Access Compliance Report Public Rights-of-Way (Curb Ramps)

Main Street: DUNAS_RD Cross Street: FAIRHAVEN_AVE Location: NE

ADA ID: RPAT211022094231 Ramp Type: Type 1 - Perpendicular Diagonal Initial Pass/Fail: Fail Overall Compliance: No Severity Score: 15

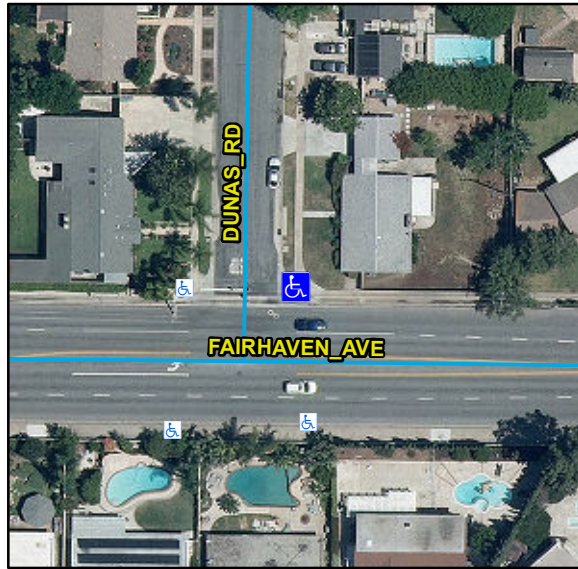
Compliance	Description	Data	Compliance	Description	Data
N/A	Ramp Length (in)	48	N/A	Flare Type LT	
Yes	Ramp Width (in)	49			N/A
No	Ramp Run Slope (%)	9.7	N/A	Flare Slope LT (%)	N/A
Yes	Ramp Cross Slope (%)	0.5	N/A	Flare Traversable LT	N/A
N/A	Landing Present	N/A	N/A	Flare Type RT	
N/A	Landing Length (in)	N/A			N/A
N/A	Landing Width (in)	N/A	N/A	Flare Slope RT (%)	N/A
N/A	Landing Run Slope (%)	N/A	N/A	Flare Traversable RT	N/A
N/A	Landing Cross Slope (%)	N/A	N/A	DWS Provided	N/A
N/A	Landing Movement Obstructed?	N/A	N/A	DWS Contrast	N/A
	Landing Movement Type	N/A	N/A	DWS Length (in)	N/A
N/A	Landing Shared	N/A	N/A	DWS Full Width	N/A
N/A	Clear Space	Yes	N/A	DWS Offset Left (in)	N/A
N/A	Clear Space To Crosswalk (in)	N/A	N/A	DWS Offset Right (in)	N/A
N/A	Marked Crosswalk 1	No	N/A	Marked Crosswalk 2	No
	Crossing 1 Direction	W		Crossing 2 Direction	S
	Marked Crosswalk 1 Width (in)	N/A		Marked Crosswalk 2 Width (in)	N/A

N/A	Ramp Inside Crosswalk 1	N/A	Yes	Ramp Inside Crosswalk 2	N/A
	Crossing 1 Slope (%)	0.5		Crossing 2 Slope (%)	4.7
	Crossing 1 Cross Slope (%)	2.6		Crossing 2 Cross Slope (%)	1.5
N/A	Gutter Ponding	N/A	No	Curb Slope	7.3
Yes	Gutter Lip Height (in)	0		Road Run Slope (%)	1.5
N/A	Gutter Run Slope (%)	N/A		Road Cross Slope (%)	3.4
N/A	Gutter Cross Slope (%)	N/A			
Yes	Overall Surface Condition: Acceptable		Yes	Perp Joint Present	Yes
	Cross Gutter Present?	Yes		Spandrel Present?	Yes
	Replace Cross Gutter?	No		Replace Spandrel?	No

Remove & Replace Curb Ramp With Two New Directional Ramps or Equivalent.

R304.2.2, STD 1115
